APPLICATION FOR HISTORIC AREA WORK PERMIT

LOCAL ADVISORY COMMITTEE REVIEW FORM

c. Address of Property: 7425 Buffalo Avenue
Takoma Park, MD 20912

Restore altered portions of front facade: replace deteriorated brick steps and iron railing with wood steps, wood railing, and Tuscan wood column

Front Steps Elevation

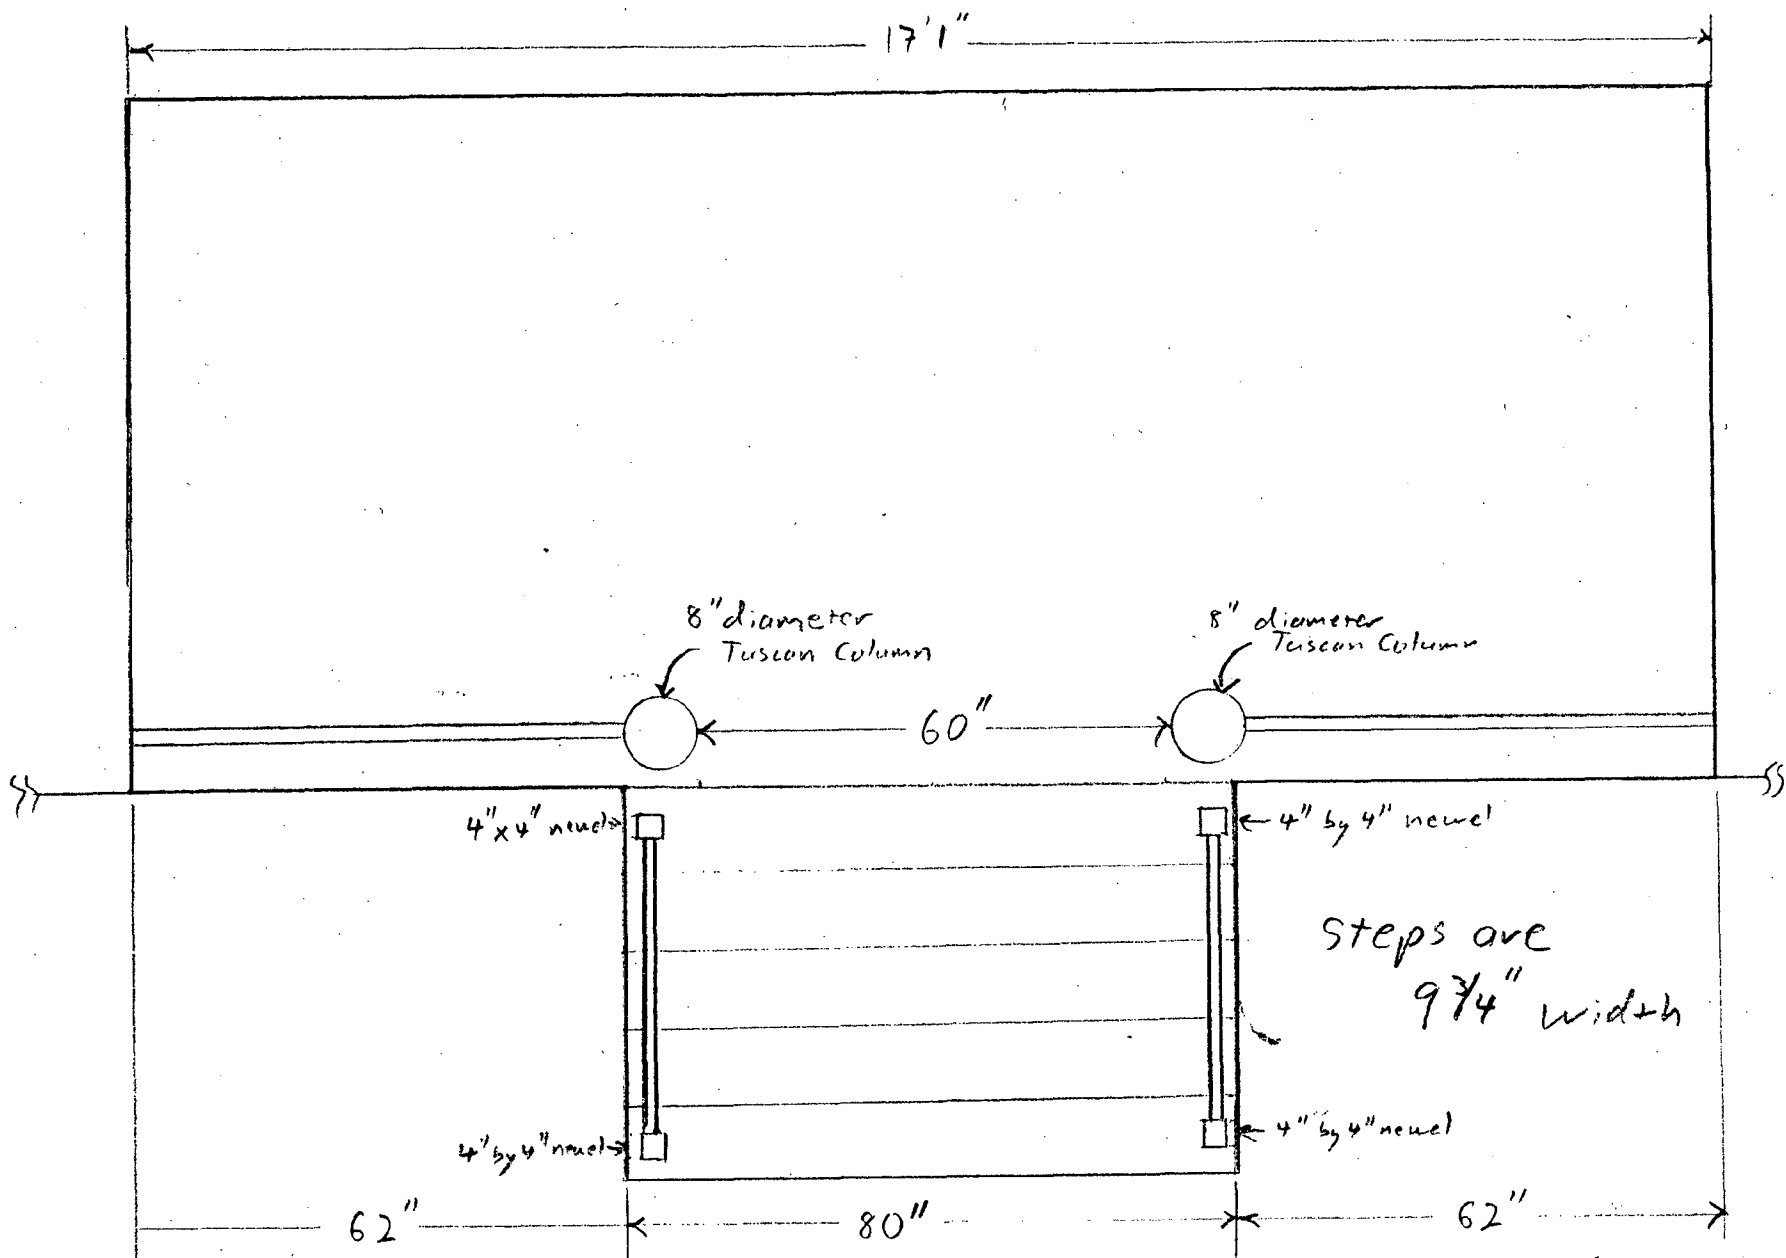
very compatible-this is a nice restoration which will certainly improve the appearance of the historic streetscape

2

New work should be painted.
